From: Donna Tisdale <tisdale.donna@gmail.com>
Sent: Wednesday, December 04, 2013 4:09 PM
To: Gungle, Ashley; Hingtgen, Robert J; Bennett, Jim; Fogg, Mindy
Cc: Jacob, Dianne; Wilson, Adam
Subject: Soitec Solar DPEIR / BAD submission

Please include Dr. Victor M. Ponce's linked report, **The Impact of Soitec Solar Projects on Boulevard and Surrounding Communities**, as advance comments to be included in the record for the pending Soitec Solar Draft PEIR: <http://boulevardsoitec.sdsu.edu/>.

**IMPACTS OF SOITEC SOLAR PROJECTS
ON BOULEVARD AND SURROUNDING COMMUNITIES,
SAN DIEGO COUNTY, CALIFORNIA**

December 2, 2013

Fig. 14 LanWest Solar plot plan [Click on image to enlarge].

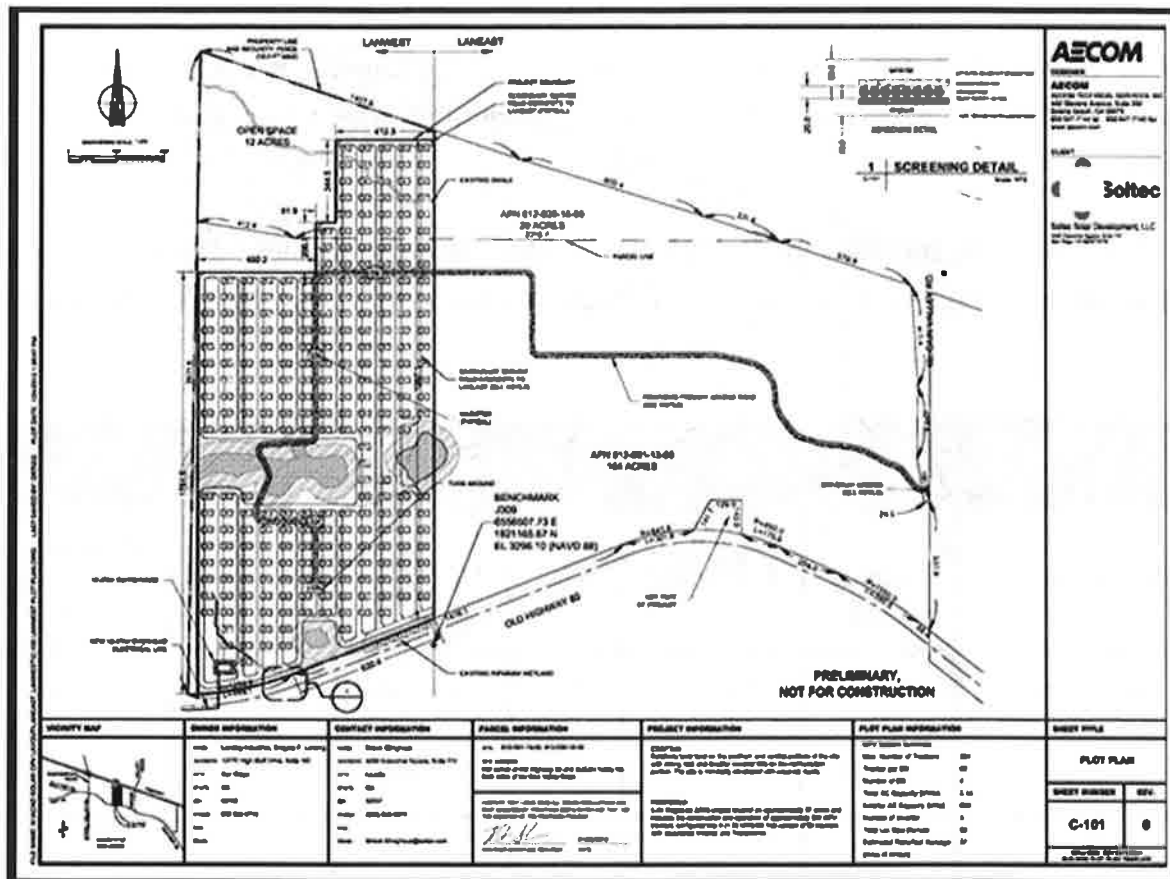
The current LanWest plot plan assures the risk of flooding in the event that Walker Creek were to reach flood stage (Section 6.3). With the everpresent threat of global climate change, a heightened flood risk remains a distinct possibility. This is particularly the case during strong El Niño events, which have hit California with recurring frequency in the recent past (Section 4.1).

Fig. 43 Walker Creek meadow relative to LanEast/LanWest Solar [[Click on image to enlarge](#)].

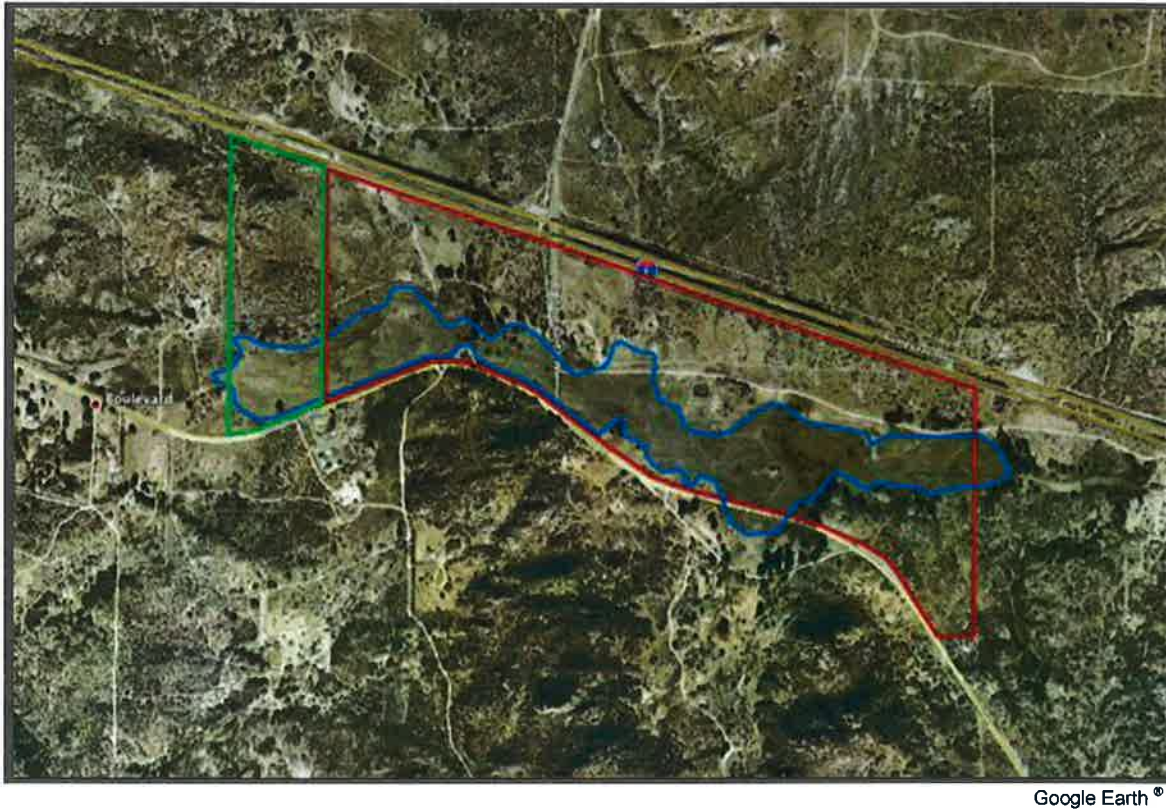
The Walker Creek meadow is delineated in blue in Fig. 43. This figure shows that the LanEast/LanWest project site encompasses almost the entire areal extent of the Walker Creek

The wisdom of placing a solar energy project directly on top of a meadow/wetland is highly questionable. A wetland is defined as a land area saturated with water, either permanently or seasonally. Proximity of the water table to the land surface is a characteristic of wetlands. Wetlands perform a host of natural services, including sediment retention, nutrient and pollutant uptake, carbon sequestering, migratory bird habitat, and visual aesthetics, among others. In the United States, a federal policy of wetland protection has been established since 1989.¹⁷

The LanEast/LanWest projects are being sited, for the most part, on top of the Walker Creek meadow (Fig. 43). This is an unfortunate tactical decision (Section 6.2). This meadow performs a host of natural services, which will be eliminated or greatly compromised in the event that industrial-scale solar development takes place as planned (Figs. 44 to 46). In the event that the needed amount of project water is obtained from local wells, there is a high risk that the groundwater table may drop below historic levels, with consequent negative effects on the Walker Creek meadow and associated riparian ecosystems.

Fig. 49 Location of Walker Canyon Ecological Reserve relative to LanEast/LanWest project site
[\[Click on image to enlarge\]](#).

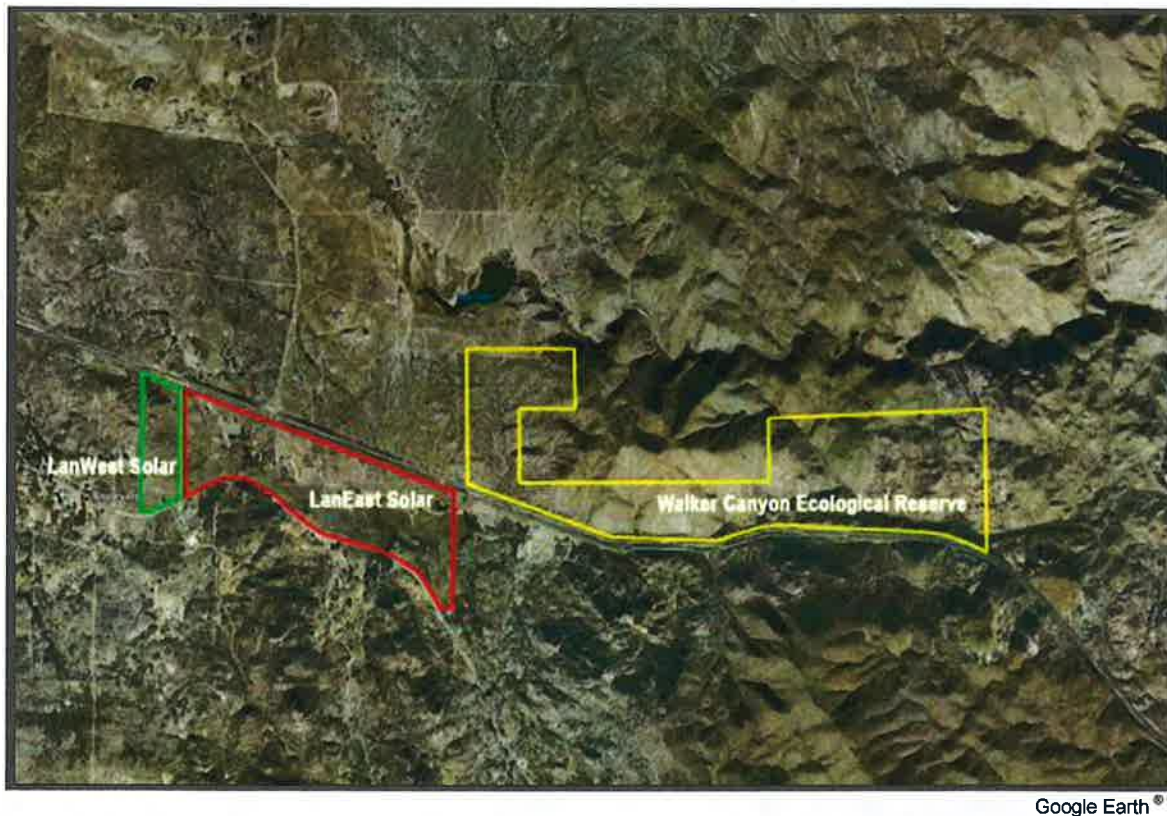
Immediately downstream from the LanEast project site, Walker Creek runs through the [Walker Canyon Ecological Reserve](#) for about 1.5 miles before reaching [the southwestern boundary of] Anza-Borrego State Park. The ecological reserve lies immediately east of the LanEast project site (Fig. 49). Therefore, groundwater pumping in the vicinity must show conclusively that it does not result in a significant impact to the reserve.
